RE: Permit # DONH-COA-01812 – The Doyle Building LPB Briefing #2 Package Corrections

LANDMARKS PRESERVATION BOARD THE DOYLE BUILDING - BRIEFING #2

119 Pine Street, Seattle, WA 98101

4.1 - DEMOLITION SCOPE

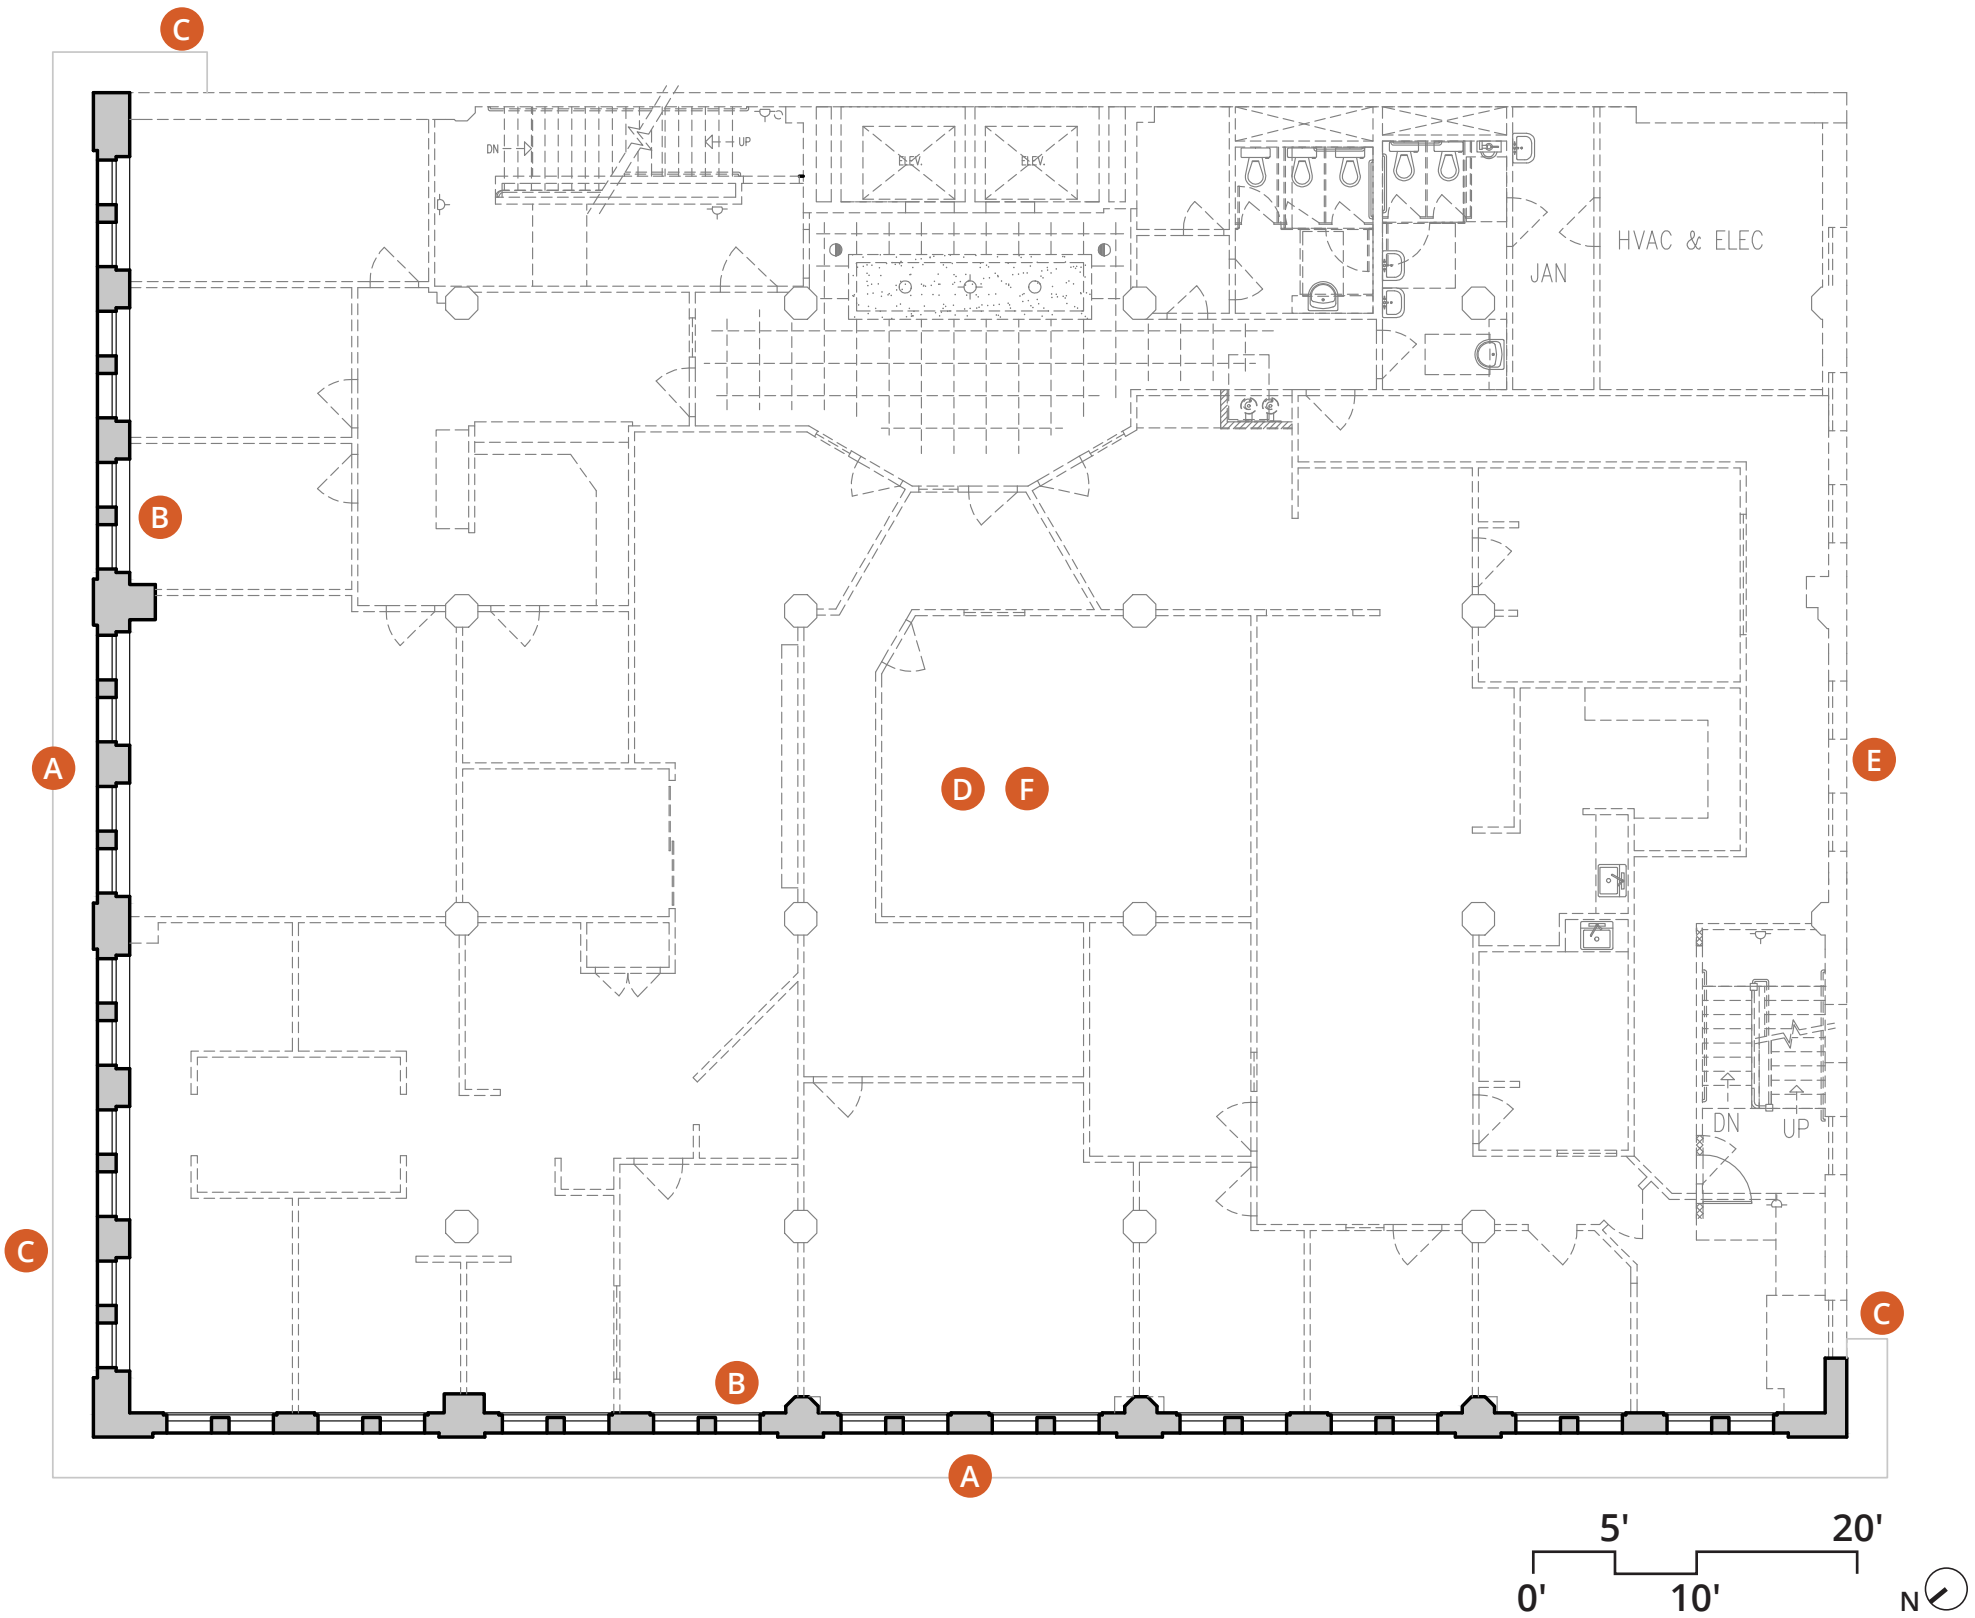
- 2. Thank you for clarifying that you proposed to demolish the building and only retain two of the facades. How will this be achieved? The packet says it will be protected in place. You can provide a basic concept for this?*

CB RESPONSE: The Project will preserve the existing Pine Street and 2nd Avenue facades, which are the primary controlled features, while constructing a new concrete structure within to support the mass timber addition. The facades will be protected and braced during construction. The means and methods for the façade bracing and protection during the construction will be developed by the general contractor and submitted with the Certificate of Approval application for the Board's review and approval.

4.5 - PARTIAL ELEVATION & SECTION

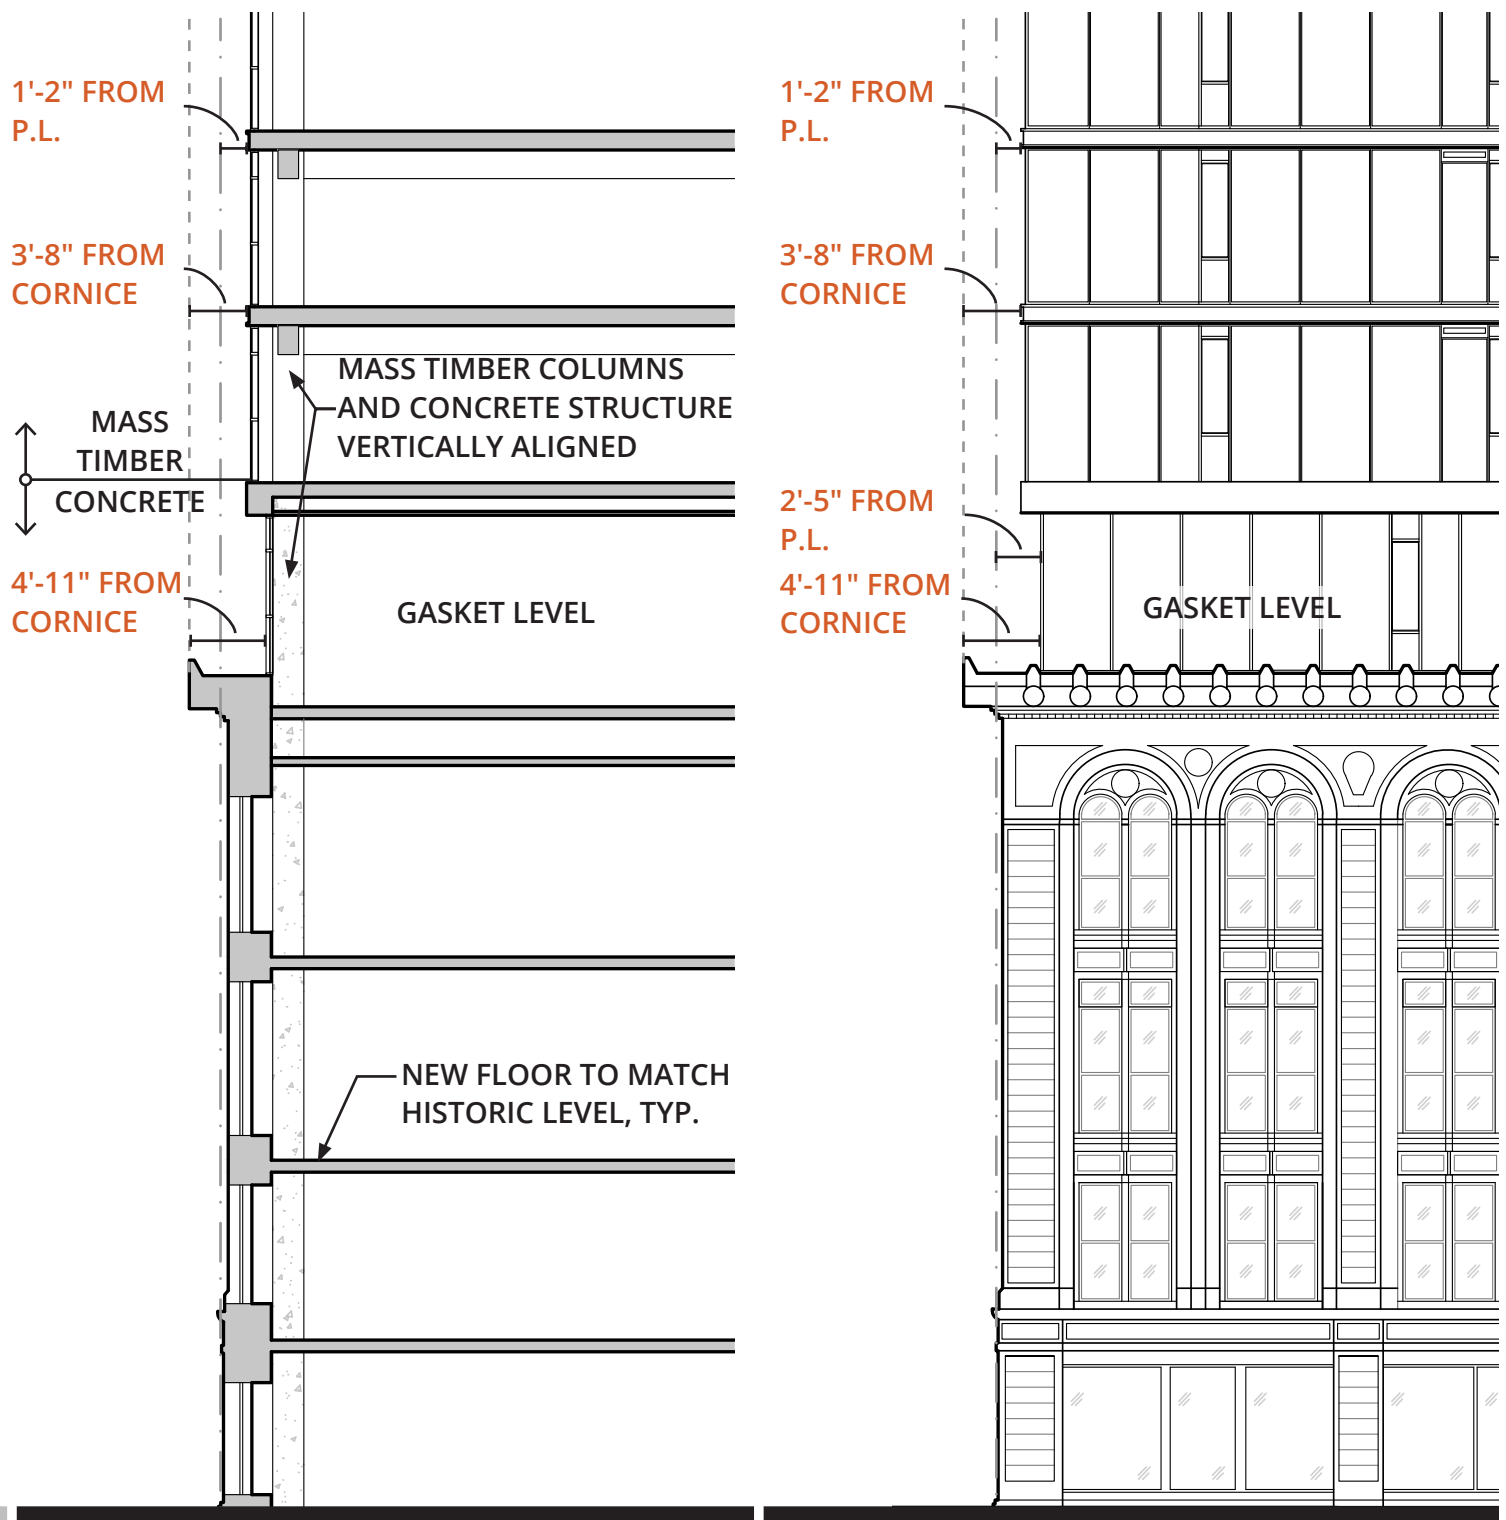
- 1. It appears that the current tower design is for an 18-story addition, as opposed to the 12-story addition from the briefing in 2025? Can you explain why you have added 6 floors?*

BRIEFING #1 - PINE STREET PARTIAL ELEVATION & SECTION

BRIEFING #2 - REVISED PINE STREET PARTIAL ELEVATION & SECTION

CB RESPONSE: Per the legislation House Bill 1183 and Seattle Ordinance 127445, mass timber structures are not subject to tower separation and setback requirements. Therefore, we have increased the height and number of stories for the project per the mass timber building code.

As with the previous 12-story scheme, the current design will retain and protect the landmark's primary controlled features, the East and North facades, during construction. The increased height does not change the Project's commitment to preserving the two street-facing façades or the approach to their protection and retention.
